# City of Fredericksburg

Historic Review Board Meeting Agenda  
Tuesday, July 8, 2025 ~ 5:30 PM  
New City Hall at East Campus  
2818 E. U.S. Hwy. 290  
Fredericksburg, Texas 78624

**HISTORIC REVIEW BOARD  
MEETING MINUTES  
June 10, 2025  
5:30 PM**

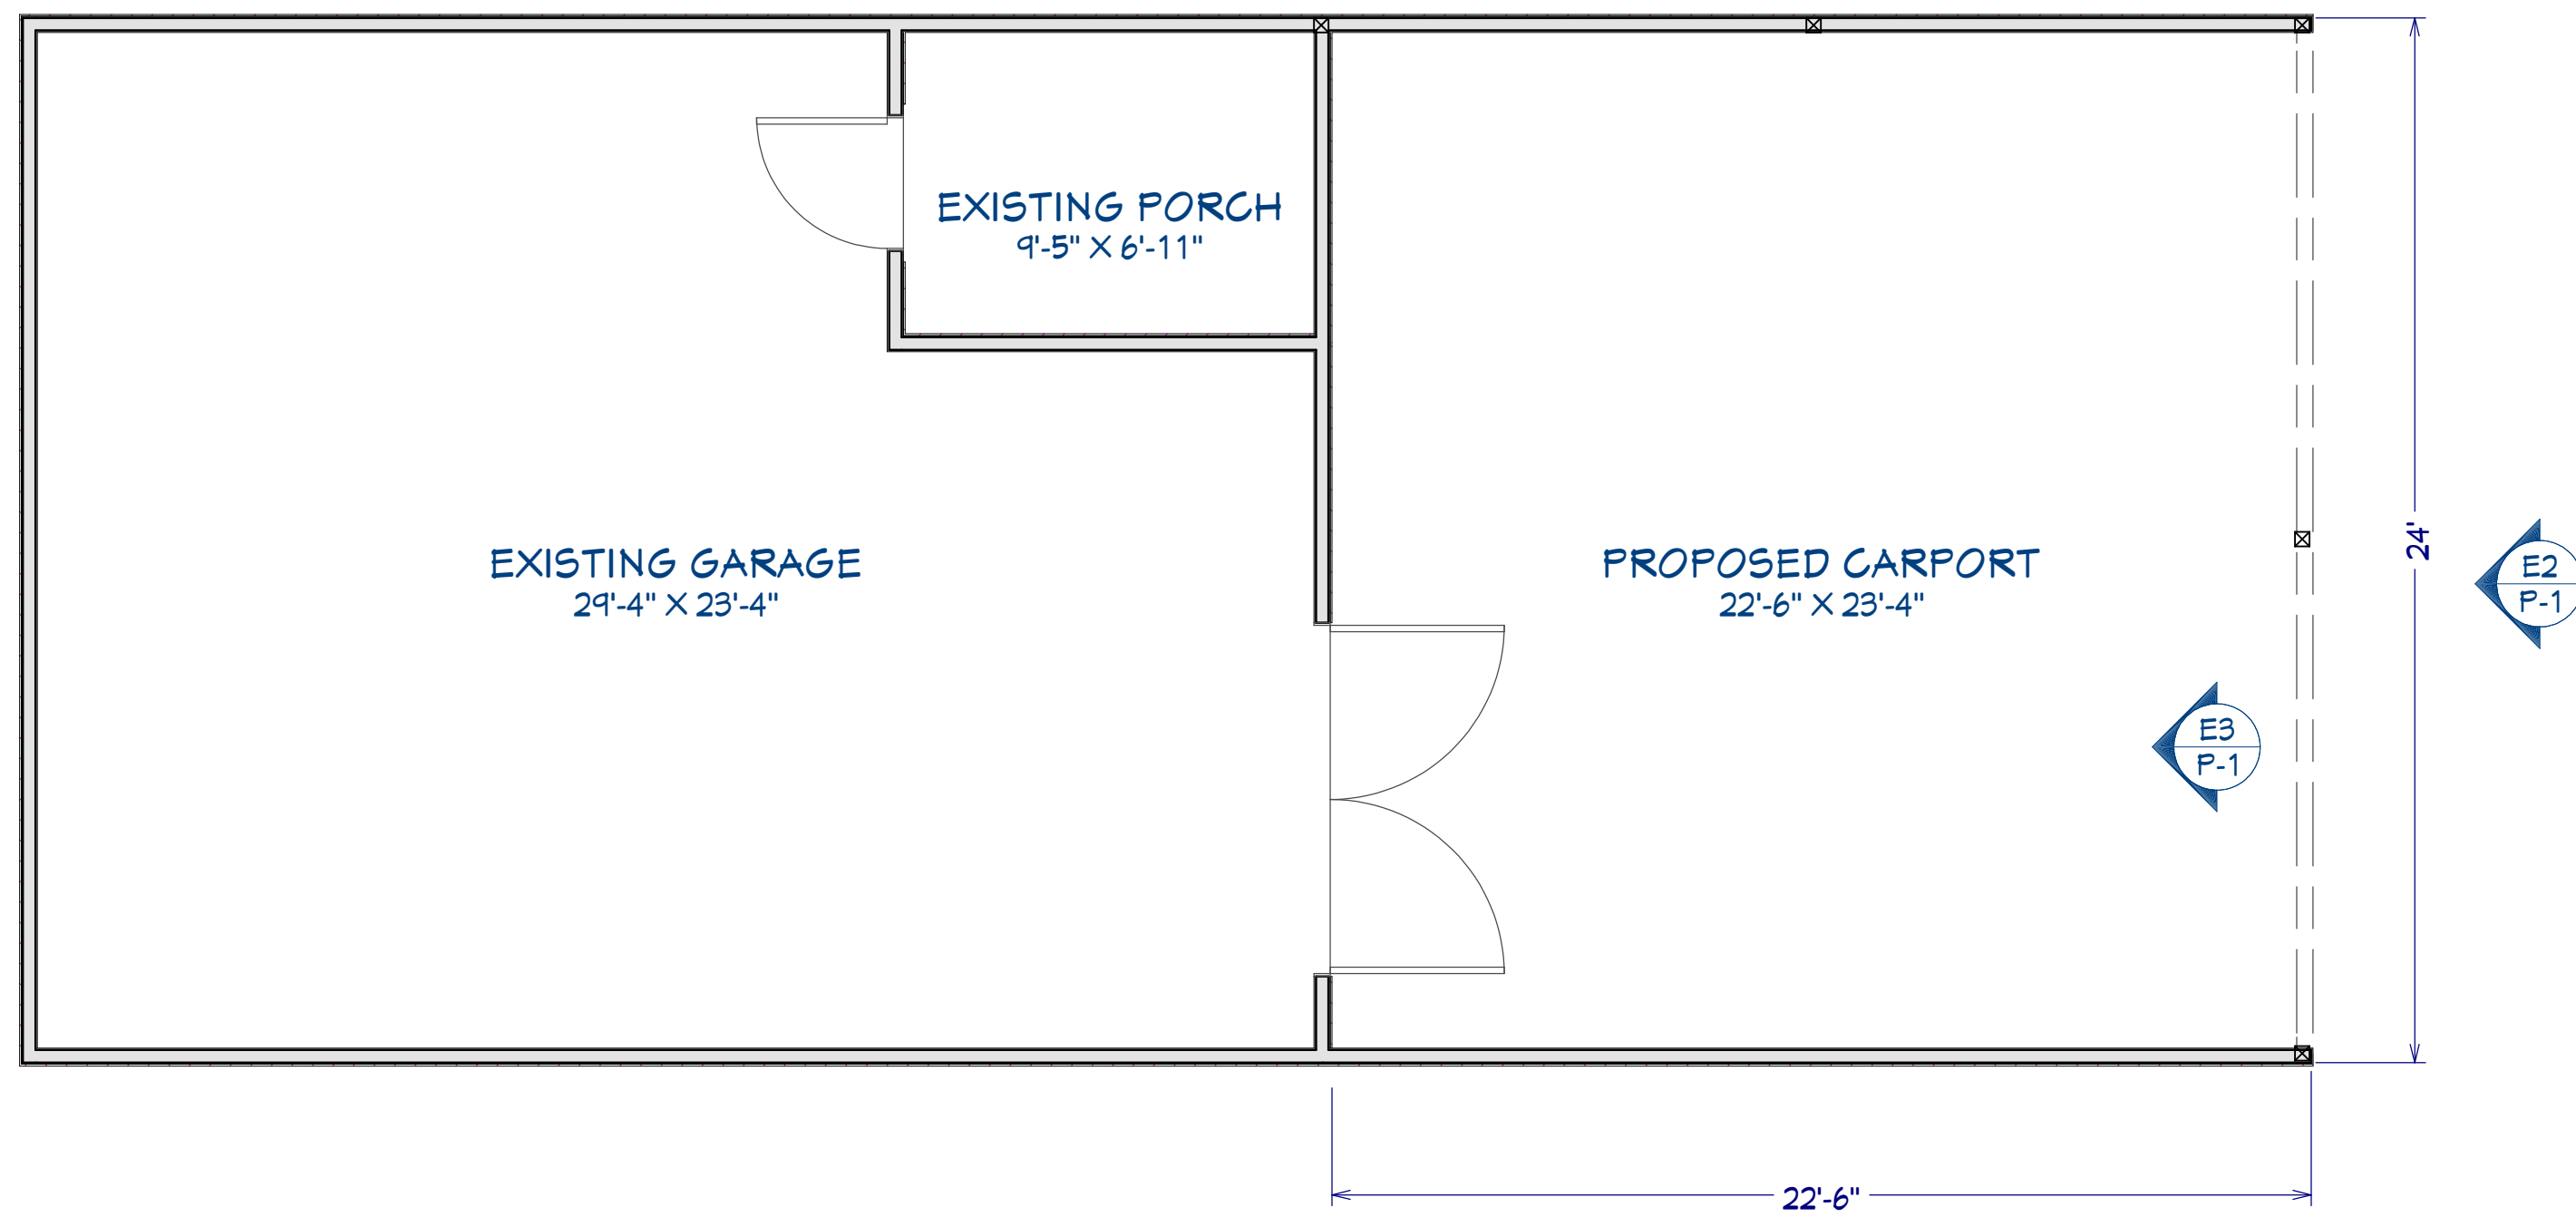
Maintain appropriate setbacks of exterior materials for new accessory buildings and should not use more than two different primary siding materials; a third material may be added if used for trim only. At least one exterior material on the accessory building must match the primary building on the property. setbacks between new accessory buildings and historic primary buildings on the property, reflecting historic patterns within the district, unless granted an exception due to small lot size (e).

The palette of exterior materials for new accessory buildings should not use more than two different primary siding materials; a third material may be added if used for trim only. At least one exterior material on the accessory building must match the primary building on the property.(i)

The exterior color palette for new accessory buildings must generally be in the same range as the primary building on the property.(k)

Staff recommends approval based upon the utilization of similar materials and paint to the existing garage.

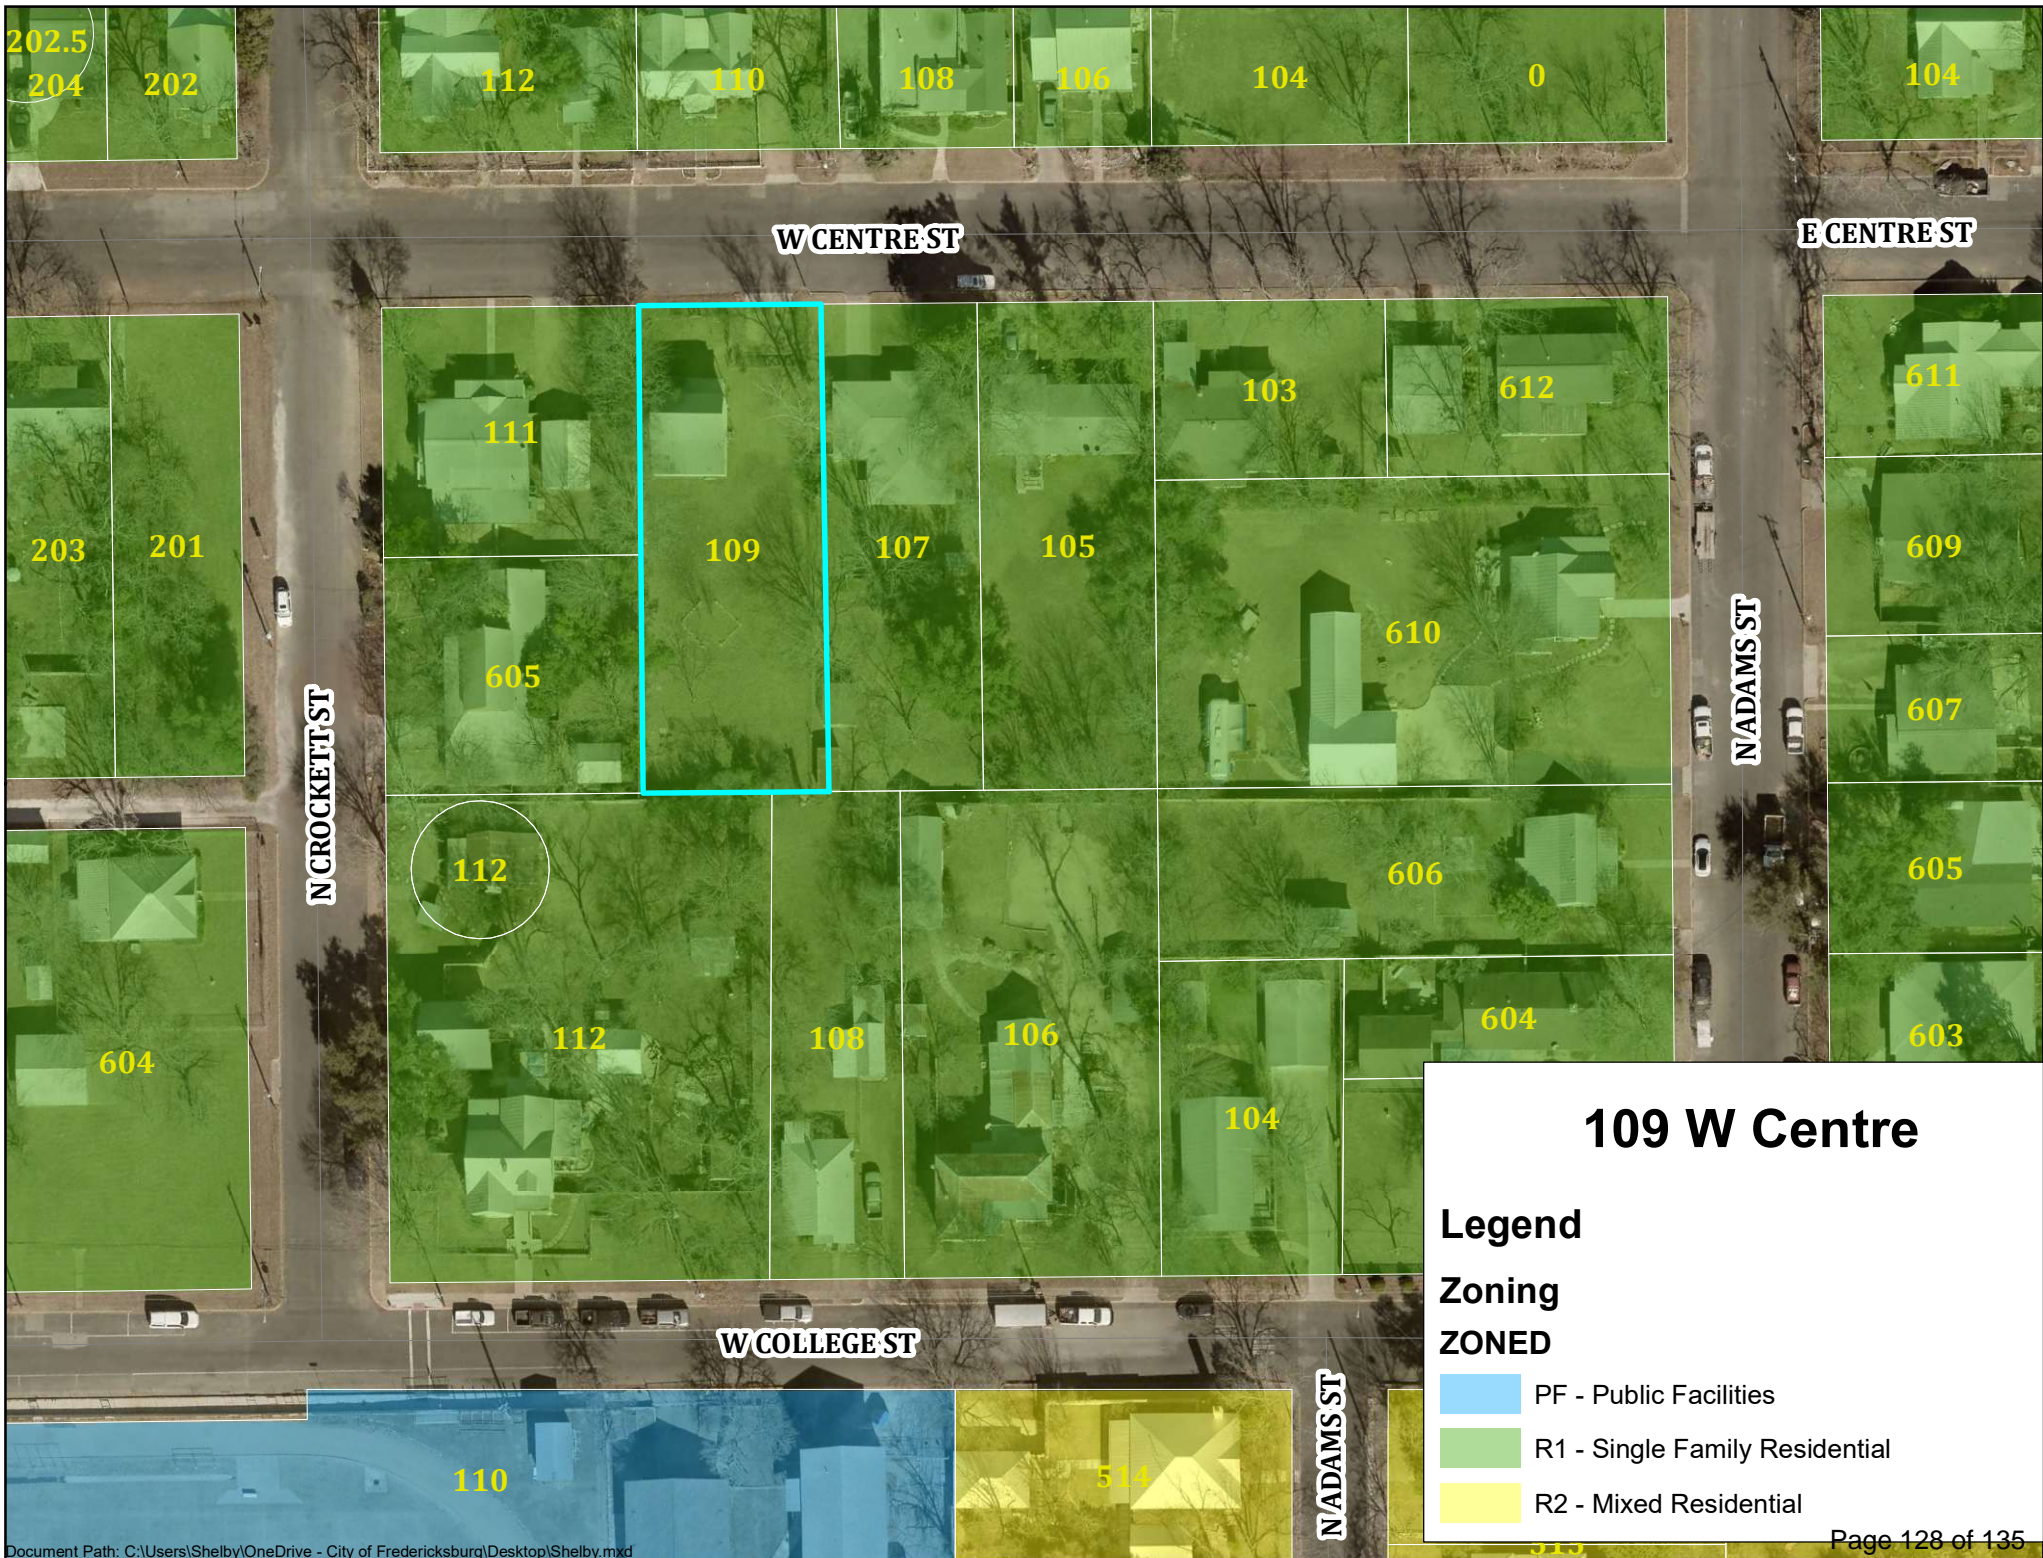
Design the new site plan so that it generally reflects the character-defining features of the prevalent neighboring complex types (b). Consider maintaining historic-site development patterns for the relevant complex type discussed in section 2.3; for example, residential rear yards should maintain a central open core for domestic and recreational use, and industrial complexes should maintain wide circulation paths historically needed for machinery (c). Appropriate setbacks from the property lines must be consistent with the surrounding context; This may allow setbacks that are deeper or shallower than the base zoning (d). Maintain appropriate setbacks between new accessory buildings and historic primary buildings on the property, reflecting historic patterns within the district (e). The maximum lot coverage allowable will not exceed the base zoning (R1) Maximum allowable lot coverage may be less than the base zoning after deducting the required setbacks from the property lines and setbacks from the historic primary buildings on the property (f). All accessory buildings, except any accessory dwelling building subject to Sec. 3.4.1(g), shall not exceed 800 sq ft OR 50% of the primary building square footage, whichever is greater (h). Locate off-street parking to the rear of the site, unless it will entail impacting a historic resource or landscape feature; the side of the property may be permitted in some instances (j).

The development as proposed is consistent with traditional and historical development patterns 3.4.1(b)(c). The transition from demolition to preservation is always welcome, and the proposed modifications are appropriate per 3.3 which allows for a rear addition that is visually cohesive and clearly communicates the different dates of construction. 3.3.p.

The use of materials is appropriate and the addition of a stone wainscot along the front which transitions into the chimney is appreciated. 3.4.2 (r)(s).

Staff recommends approval of the application as presented.
